Groundwater and Wastewater Services File Imaging Project
May 2007
Barcode Font = IDAutomationHC39M

RE: Property located at Danby Subdivision
FILE: 6999A
PARCEL: PO 223-012-06

MECKLENBURG COUNTY HEALTH DEPARTMENT
SITE EVALUATION REPORT
SERIAL NUMBER 16665

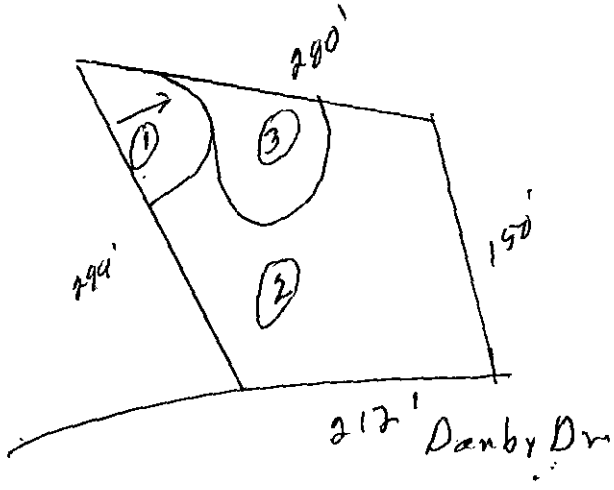
Comments: 100% Repair

FACTORS	AREA 1	AREA 2	AREA 3	AREA 4	AREA 5	AREA 6
Topography	S (PS) U 10-25%	S PS (U) complex slopes	S PS (U) Drainageway Depression	S PS U	S PS U	S PS U
Texture	S (PS) U Clay	S PS U —	S PS U —	S PS U	S PS U	S PS U
Structure	S (PS) U Blocky	S PS U —	S PS U —	S PS U	S PS U	S PS U
Drainage	S (PS) U >36" to water	S PS U —	S PS U —	S PS U	S PS U	S PS U
Depth	S (PS) U 40"+	S PS U —	S PS U —	S PS U	S PS U	S PS U
Restrictive Horizons	S (PS) U 740"	S PS U —	S PS U —	S PS U	S PS U	S PS U
Available Space	S PS (U) Restricted	S PS U —	S PS U —	S PS U	S PS U	S PS U
Other (specify)	S PS U	S PS U	S PS U	S PS U	S PS U	S PS U
Soil Group/Series	IV Cecil/Lilo	Complex slopes	Drainageway Depression			
Area Classification	S PS (U)	S PS (U)	S PS (U)	S PS U	S PS U	S PS U
